KANSAS GAS AND ELECTRIC COMPANY

KMLNRC 83-022  
Re: Docket No. STN 50-482  
Ref: Letter KMLNRC 83-012 dated January 26, 1983,  
from GLKoester, KG&E, to HRDenton, NRC  
Subj: Draft Technical Specifications

FIGURE 3.4-2 WOLF CREEK REACTOR COOLANT SYSTEM HEATUP LIMITATIONS APPLICABLE UP TO 16 EFPY

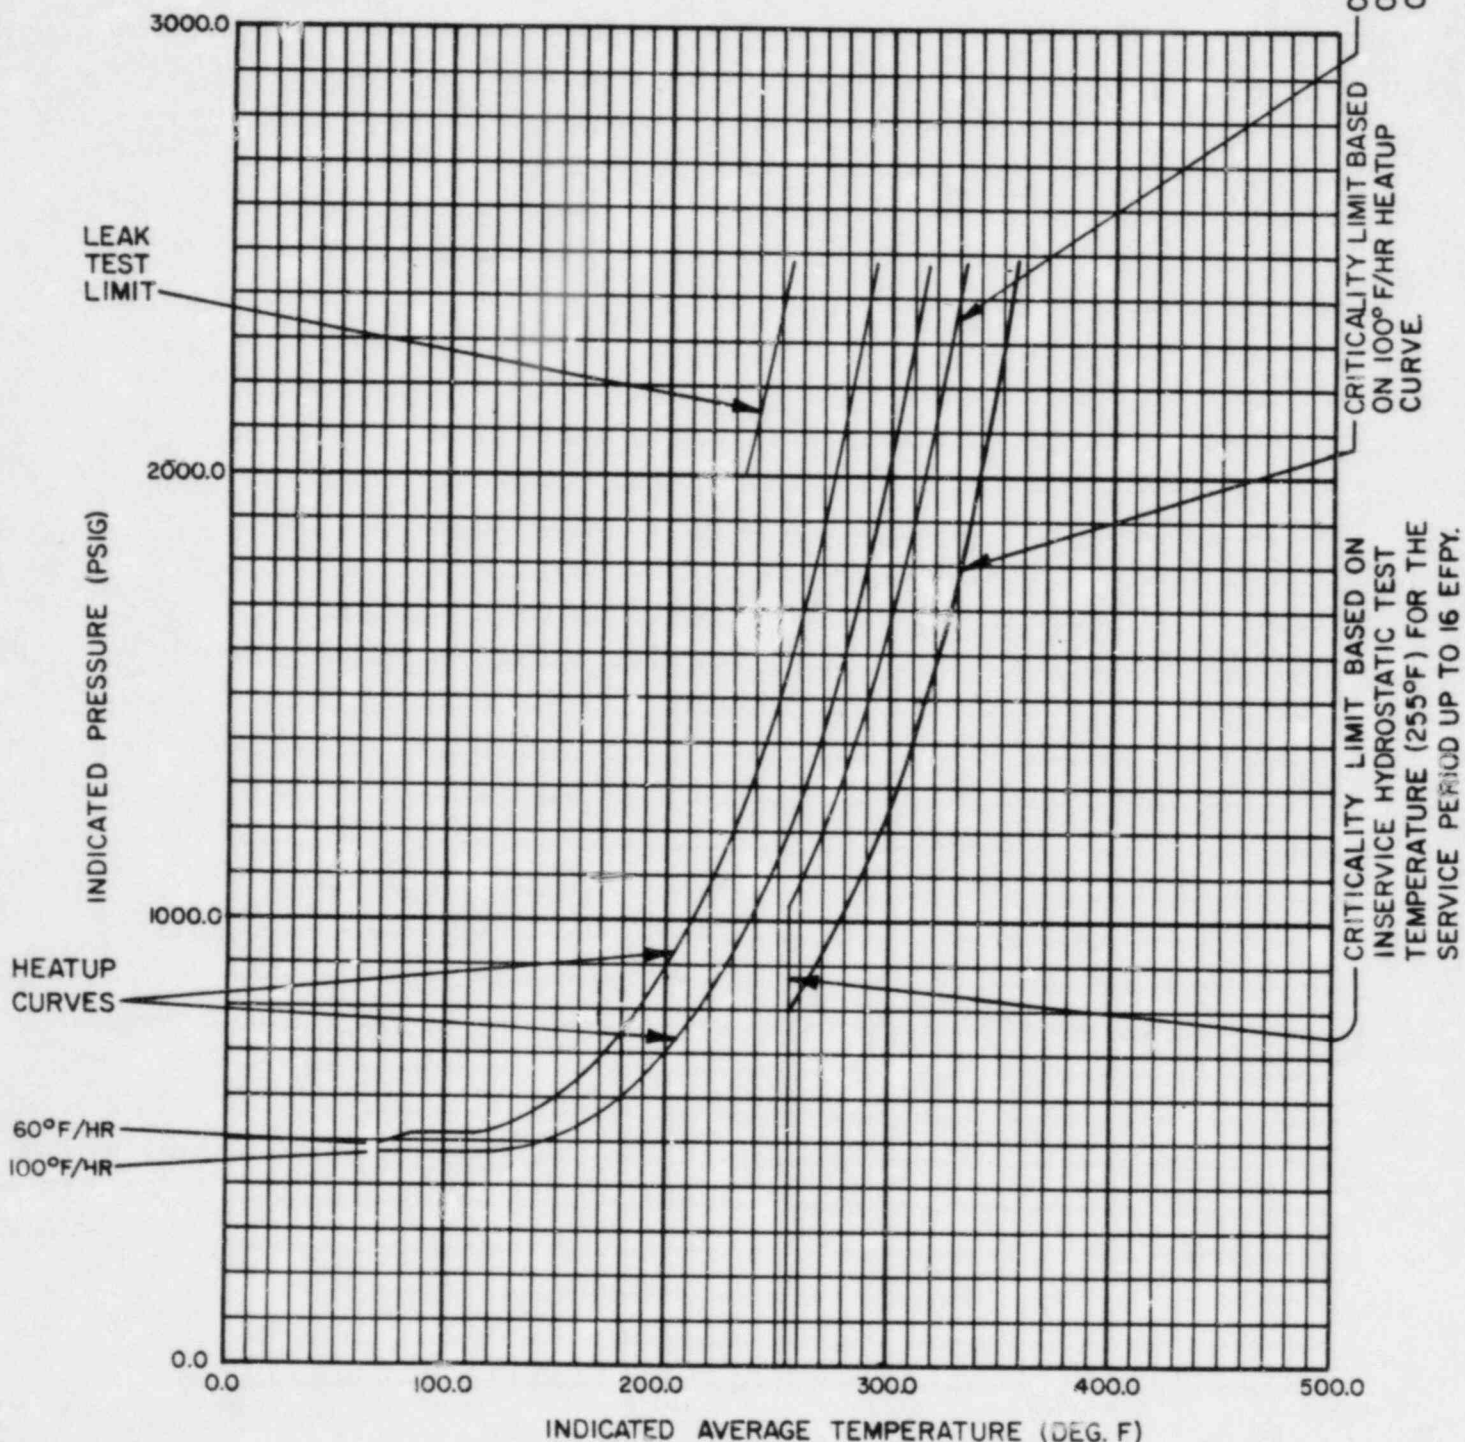
Transmitted herewith is a revised figure containing the heatup limitations for the Wolf Creek reactor coolant system. This figure should replace the identically numbered figure in the Wolf Creek Generating Station, Unit No. 1, draft Technical Specifications. This information is hereby incorporated into the Wolf Creek Generating Station, Unit No. 1, Operating License Application.

COPPER CONTENT : CONSERVATIVELY ASSUMED TO BE 0.10 WT%

RT<sub>NDT</sub> INITIAL : 40°F

RT<sub>NDT</sub> AFTER 16 EFPY: 1/4T, 100°F  
3/4T, 87°F

CURVE APPLICABLE FOR HEATUP RATES UP TO 60°F/HR FOR THE SERVICE PERIOD UP TO 16 EFPY AND CONTAINS MARGINS OF 10°F AND 60 PSIG FOR POSSIBLE INSTRUMENT ERRORS.
